CITY OF MILWAUKIE

PLANNING COMMISSION

5.12 Summary: Milwaukie High School Lake Rd Sports Complex
Applicant/Owner: 3J Consulting/North Clackamas School District
Address: 2905 SE Lake Rd & 11250 SE 27th Ave
File: CSU-2018-001, VR-2018-003, P-2018-001
Staff: Brett Kelper, Associate Planner

From: Keith Liden, Consulting Planner
Brett Kelper, Associate Planner

revisions	
phase date project	LAND USE 12.15.2017 17012
SITE PLAN PEDESTRIAN PATH PHOTOMETRICS	
E1

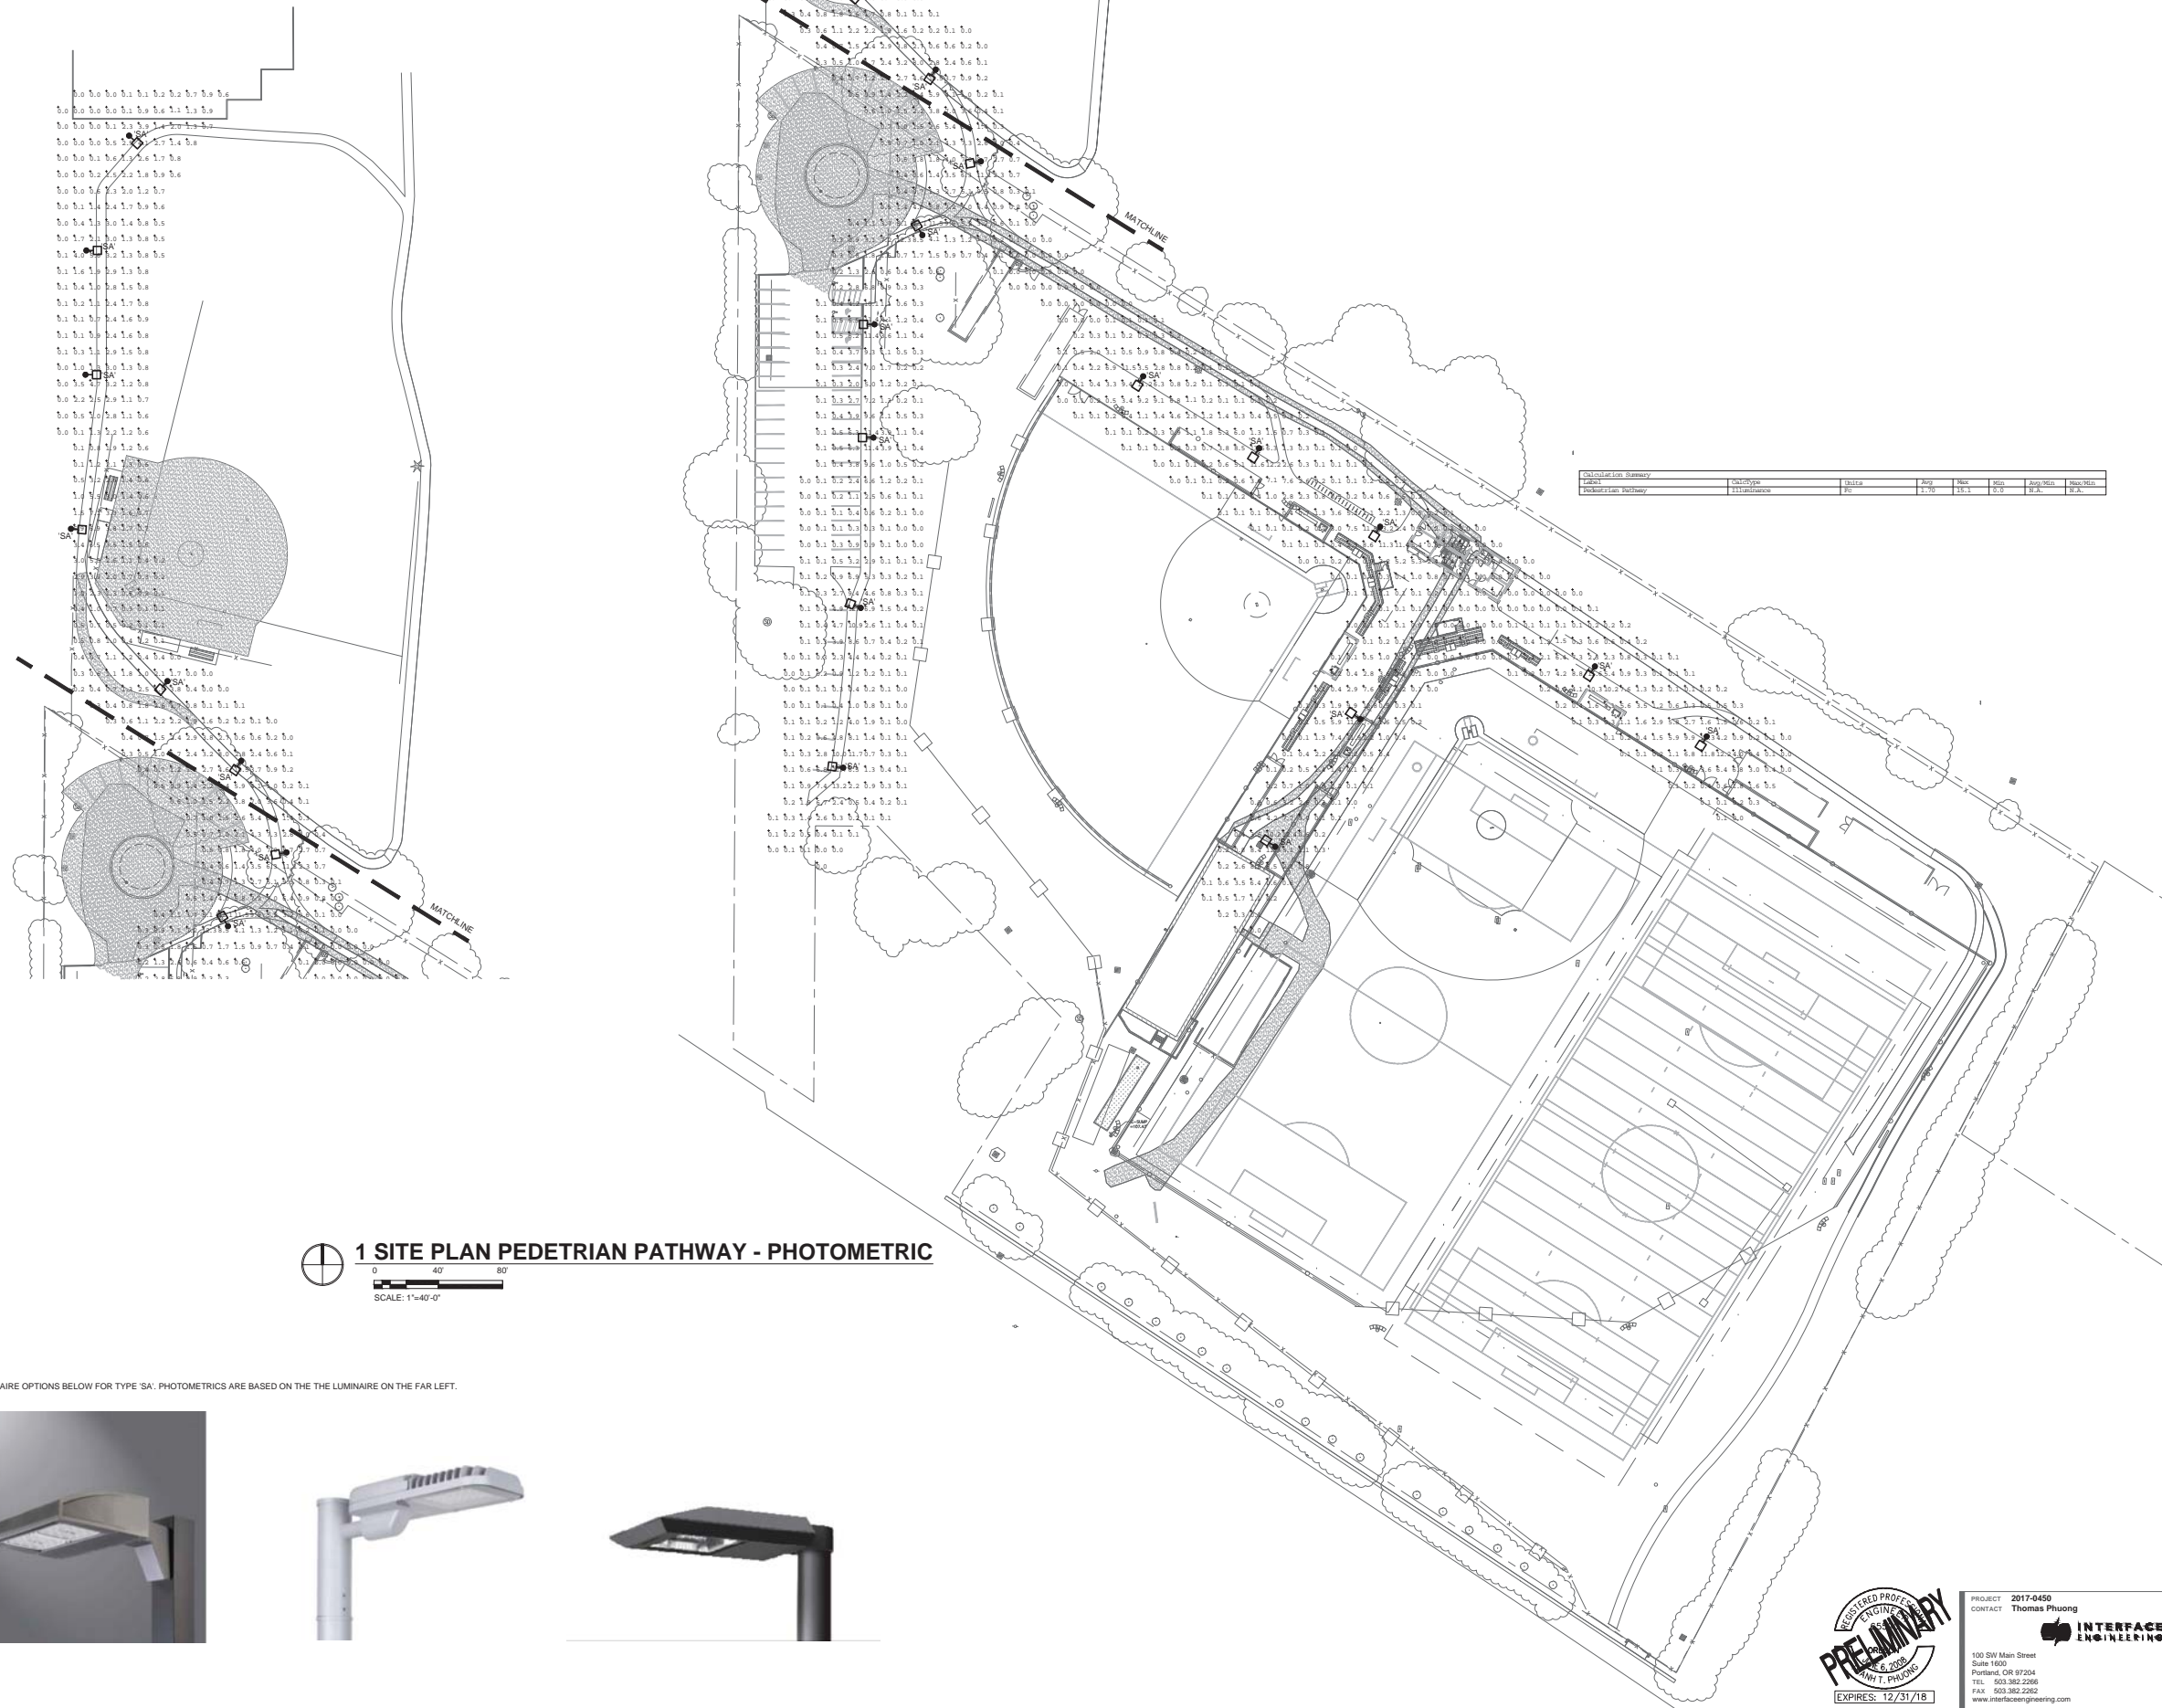
- b. The proposed pathway lighting information on Sheet E1 should be accompanied by a narrative description regarding the hours of use.

SHEET NO.
L1.0
JOB NO. NCS-30

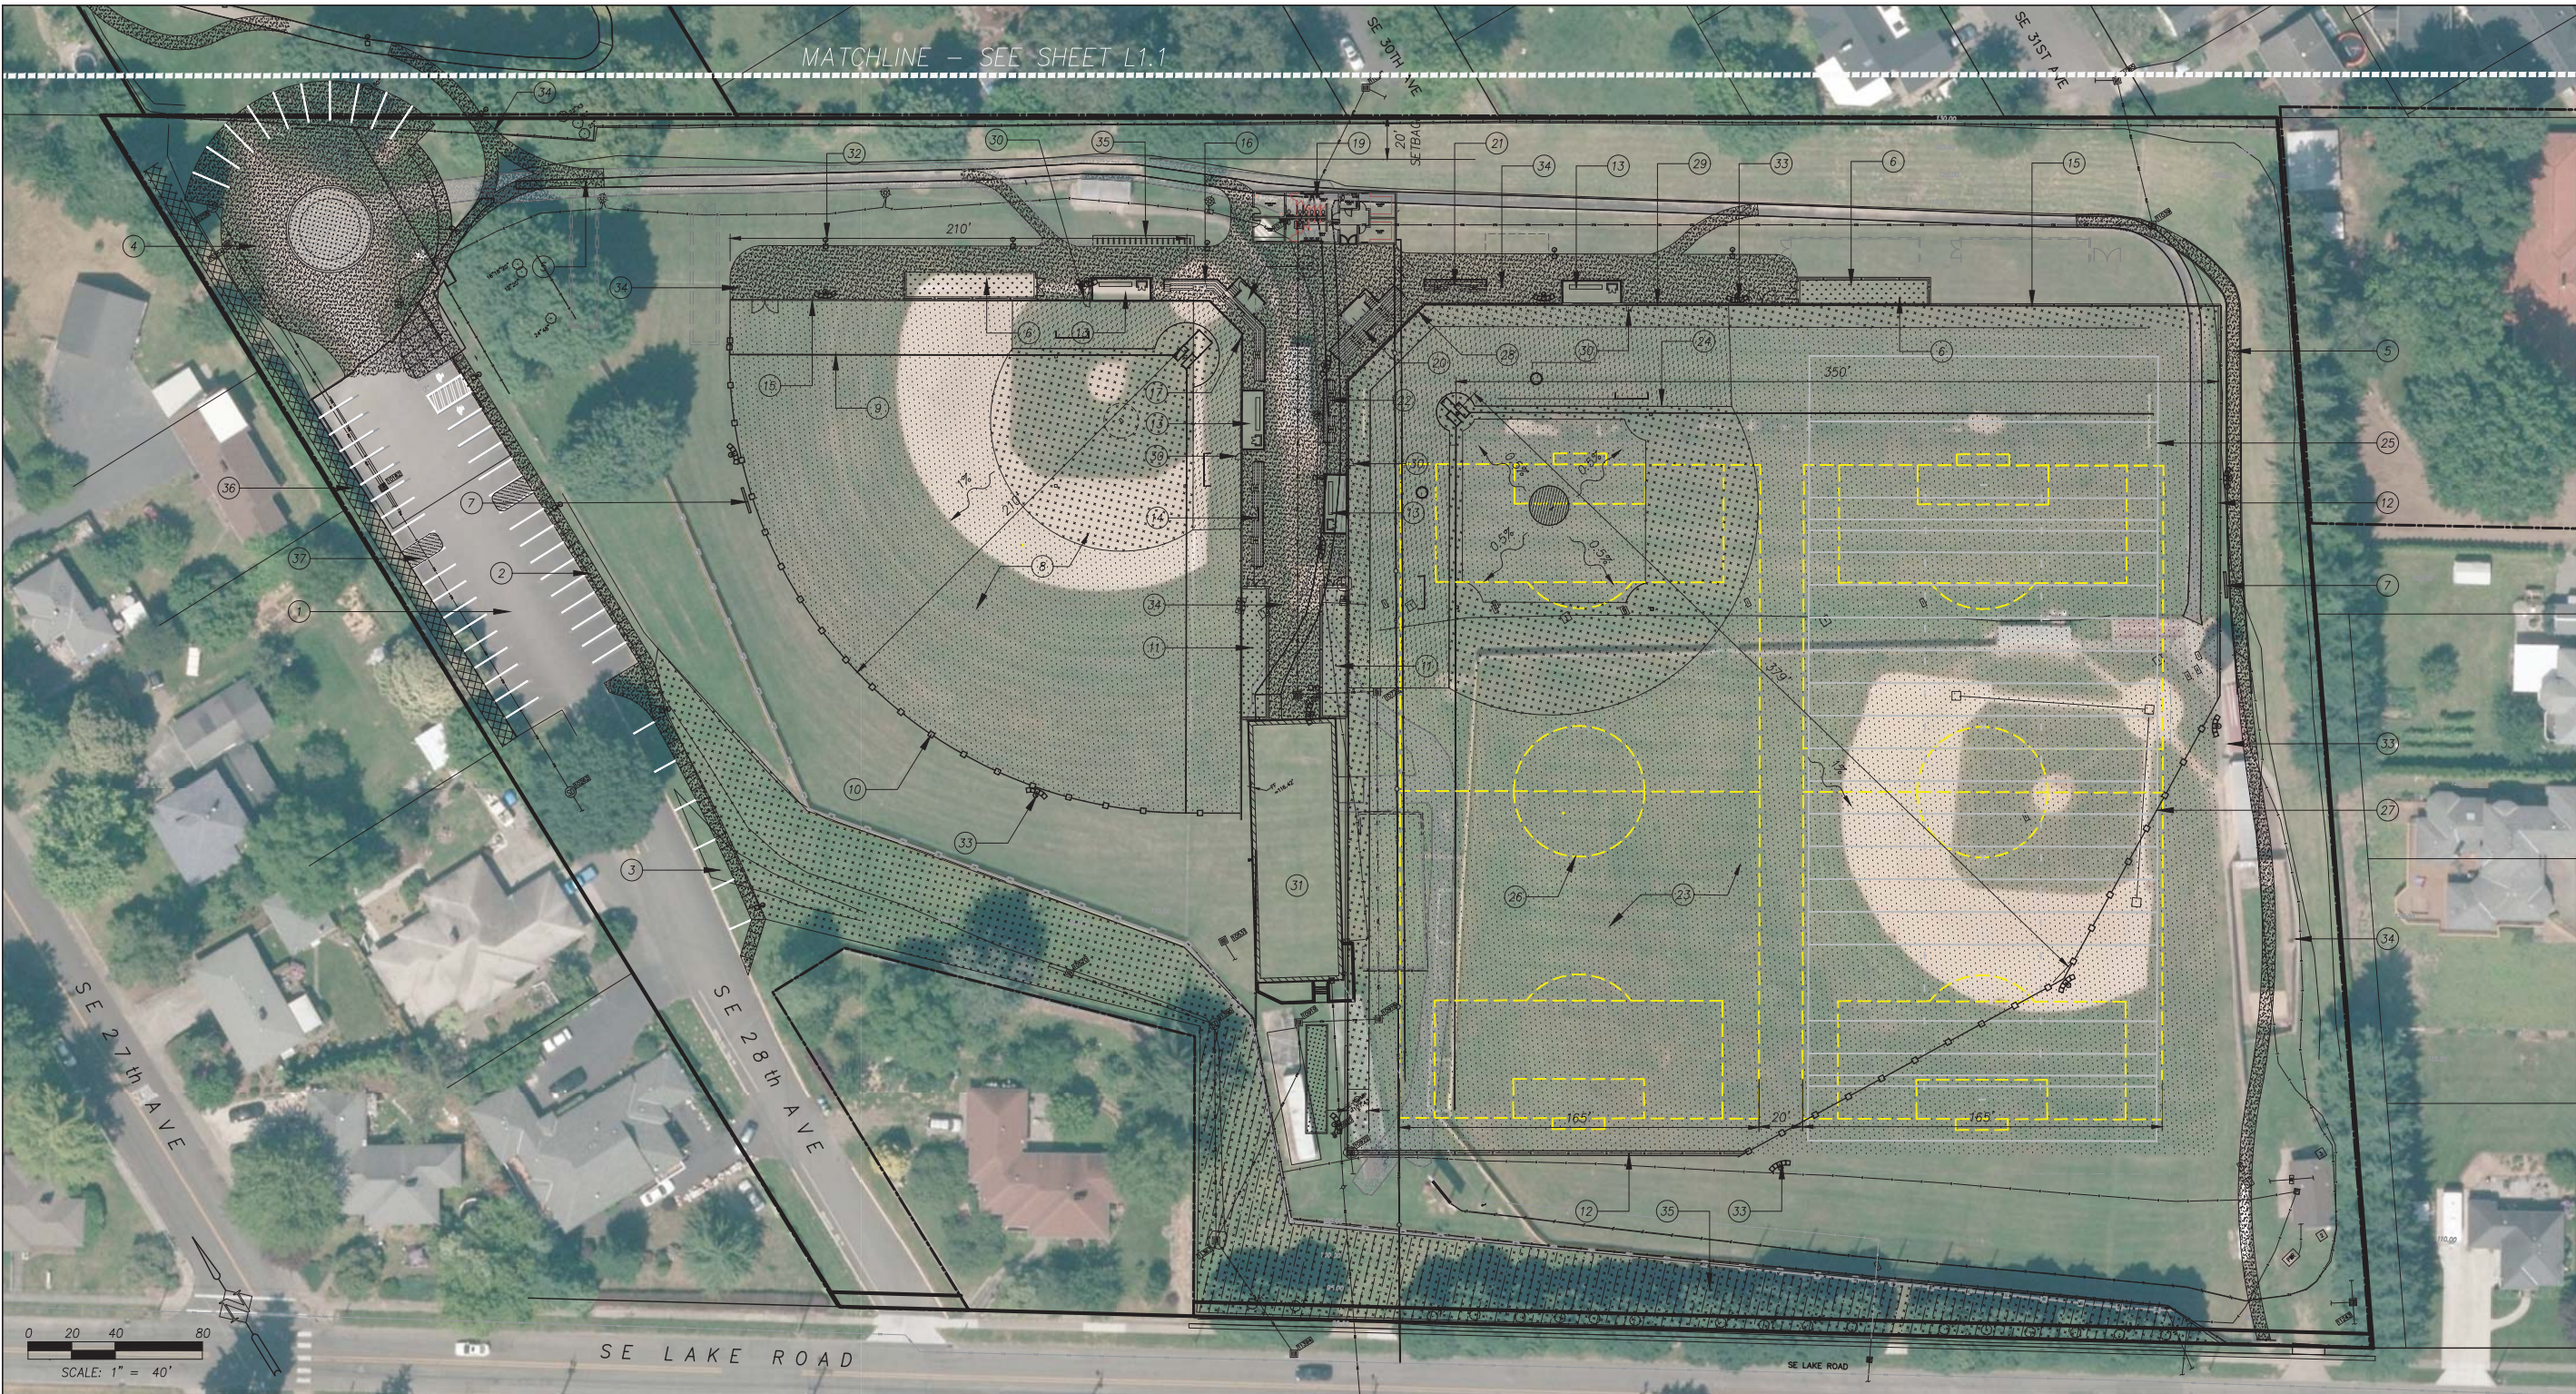
Landscaping – Note that on Sheet L1.0 it is difficult to distinguish between the areas where artificial turf is proposed and where natural grass will remain. This relates to the calculation of minimum vegetation for the site.
